Project	IEEE 802.16 Broadband Wireless Access Working Group < http://ieee802.org/16 >	
Title	Timing for sending messages using the frequency – domain energy pulses	
Date Submitted	2006-05-10	
Source(s)	Mariana Goldhamer Alvarion 21, HaBarzel Street Tel Aviv, Israel	Voice: +972 544 22 55 48 Fax: +972 3 6456241 mailto: mariana.goldhamer@alvarion.com
Re:	IEEE 802.16h-06/011 – Working Group Review	
Abstract	Proposes a more logical structure which will allow better understanding of the existing mechanisms	
Purpose		
Notice	This document has been prepared to assist IEEE 802.16. It is offered as a basis for discussion and is not binding on the contributing individual(s) or organization(s). The material in this document is subject to change in form and content after further study. The contributor(s) reserve(s) the right to add, amend or withdraw material contained herein.	
Release	The contributor grants a free, irrevocable license to the IEEE to incorporate material contained in this contribution, and any modifications thereof, in the creation of an IEEE Standards publication; to copyright in the IEEE's name any IEEE Standards publication even though it may include portions of this contrib

Figure h17—CMI Timing (CTS should be changed to CMI)

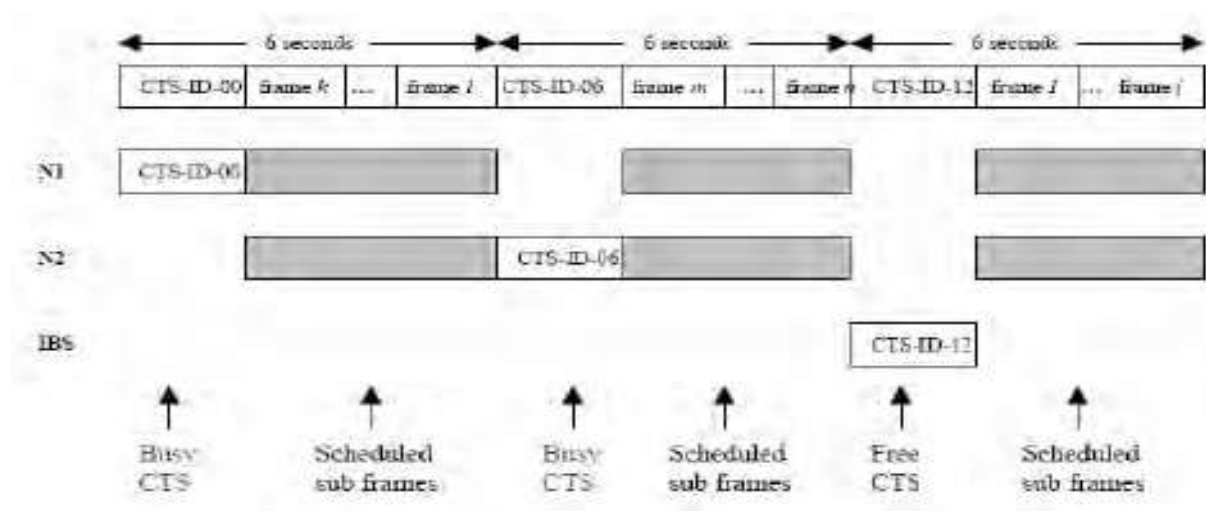
The examples provided in [1] show the possibility of starting a CTS slot at the absolute times 00:00, with increments of 6sec.

As can be seen, at 30sec the slots overlap.

It is proposed to change the period of radio signaling, to 12sec and the start of the radio signaling, to start at 3:000, 15:000, 27:000, 39:00 and 51:00sec.
